Access Compliance Report

Public Rights-of-Way

Intersection ID: 10028048	Main Street: HARTFORD_AV	Cross Street: N/A	Location: NE
ADA ID: 3E70A3A11071	Ramp Type: ParaDiag	Initial Pass/Fail: Fail	Overall Compliance: No
			Severity Score: 26.25

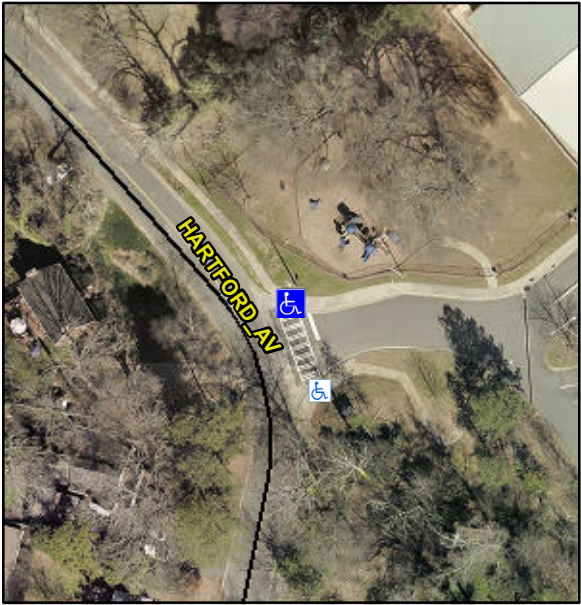
Codes/Mitigation Info/Possible Solution		Field Measurements/Component Compliance					
	Possible Solutions:						
	Remove & Replace Curb Ramp With Two New Directional Ramps or Equivalent.						
	Surveyor Notes:						
	LT RP < 5%						
	PROW/ADA:						
	R304.5.3, R304.3.2						
Street 1 Name	HARTFORD AV						
Stop Condition-Street 1	None						
Street 2 Name	ENTRANCE						
Stop Condition-Street 2	StopSign						
Total Cost:		\$	3200.00

Compliance	Description	Data	Compliance	Description	Data
N/A	Ramp Length LT (in)	60.0	N/A	Ramp Length RT (in)	63.0
Yes	Ramp Width LT (in)	60.0	Yes	Ramp Width RT (in)	72.0
Yes	Ramp Slope LT (%)	1.6	No	Ramp Slope RT (%)	12.3
No	Ramp XSlope LT (%)	2.6	Yes	Ramp XSlope RT (%)	1.7
N/A	Landing Length (in)	N/A	N/A	DWS Provided?	N/A
N/A	Landing Width (in)	N/A	N/A	DWS Contrast?	N/A
N/A	Landing Slope (%)	N/A	N/A	DWS Length (in)	N/A
N/A	Landing X Slope (%)	N/A	N/A	DWS Full Width?	N/A
N/A	Landing Curb? (Y/N)	N/A	N/A	DWS Offset (in)	N/A
N/A	Shared Landing?	N/A			
N/A	Gutter Ponding?	N/A	N/A	Gutter Slope (%)	N/A
N/A	Gutter Lip Ht (in)	N/A	N/A	Gutter X Slope (%)	N/A
N/A	Painted X Walk1?	No	N/A	Painted X Walk2?	Yes
	X Walk 1 Direction	To W		X Walk 2 Direction	To S
N/A	X Walk 1 Width (in)	N/A	N/A	X Walk 2 Width (in)	112.0
	X Walk 1 Slope (%)	8.0		X Walk 2 Slope (%)	0.0
	X Walk 1 X Slope (%)	0.6		X Walk 2 X Slope (%)	8.8
N/A	Ramp inside XWalk1?	N/A	N/A	Ramp inside XWalk2?	Yes
